Addendum # 2

Date Issued 02/26/2026

Project Name | Job # DVLS Sweetwater Elementary School HVAC upgrades 20253040

DRAWING TITLE
**FIRST FLOOR
DEMOLITION PLAN -
AREA B AND C**

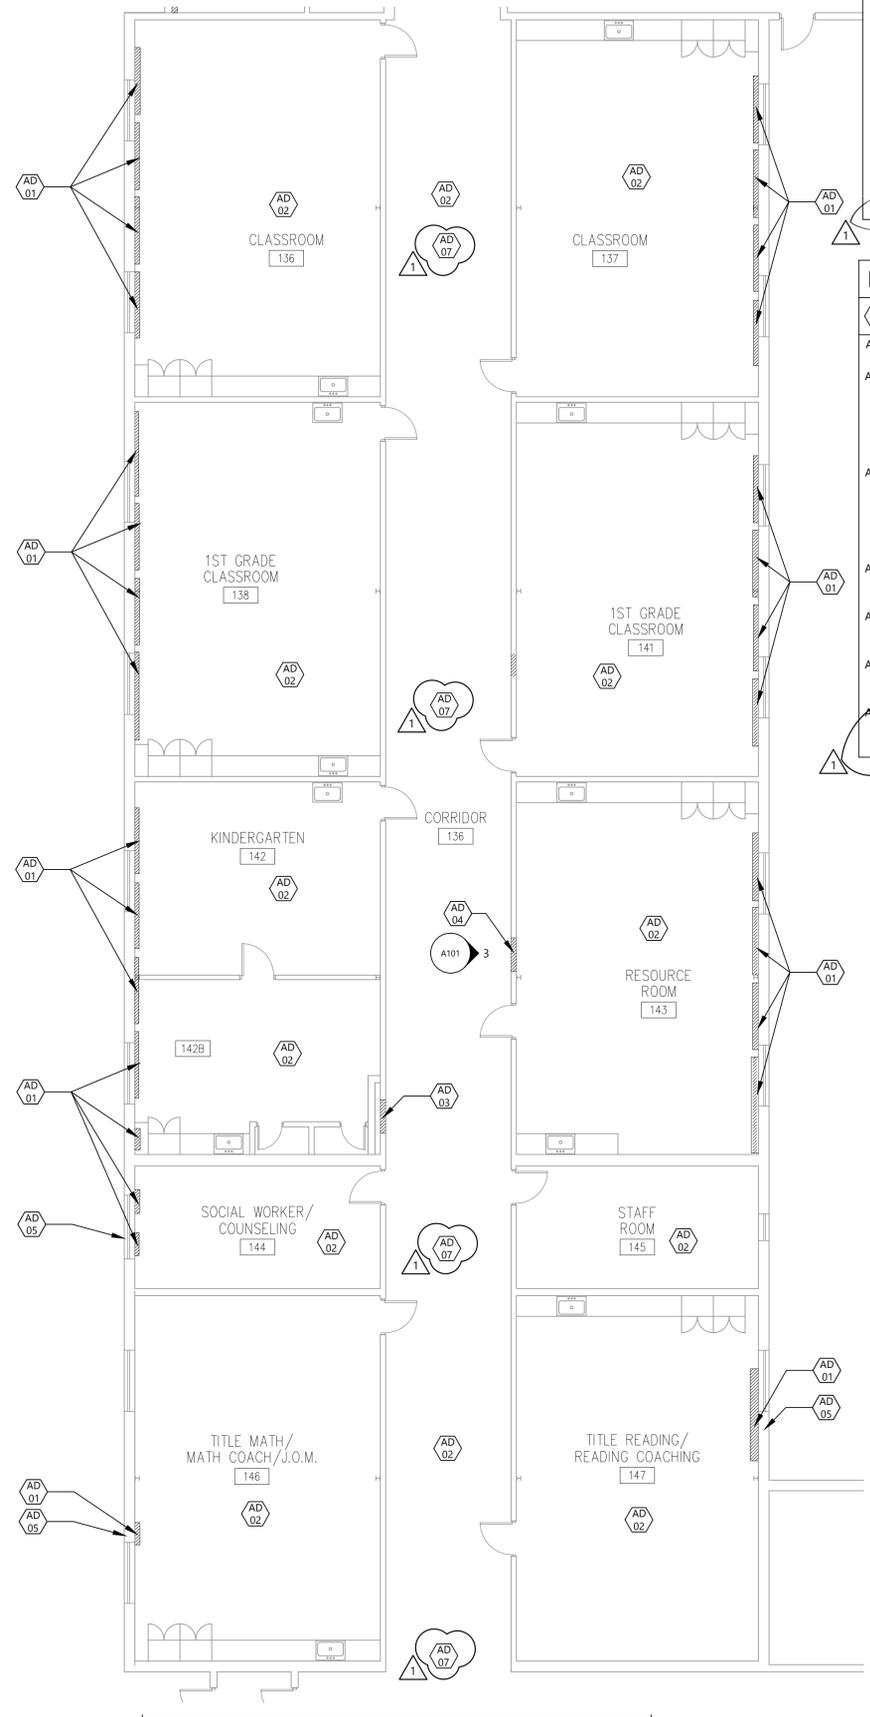
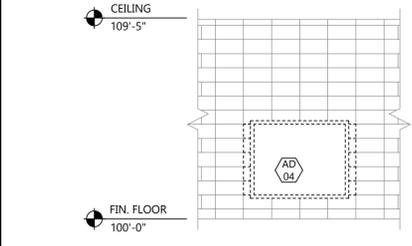
A101 Add note: Plan to accommodate mechanical penetration. Frame and gyp. small soffit directly around mechanical ductwork.

Add General Note: G.C to protect all floors during construction and repair and clean as required.

5. ALL EQUIPMENT, PLUMBING, MECHANICAL, AND ELECTRICAL SYSTEMS THAT ARE ABANDONED DURING THE PROJECT SHALL BE CAPPED AND REMOVED.
6. G.C. TO PROTECT ALL FLOORS DURING CONSTRUCTION AND REPAIR. CLEAN AS REQUIRED.

- AD 06 MECH. TO REMOVE EXISTING FIN TUBE IN CAFETERIA. COORDINATE REMOVAL WITH MECHANICAL DRAWINGS. PREPARE WALLS FOR NEW WORK.
 - AD 07 PLAN TO ACCOMMODATE MECHANICAL PENETRATION. FRAME AND GYP. SMALL SOFFIT DIRECTLY AROUND MECHANICAL DUCTWORK.
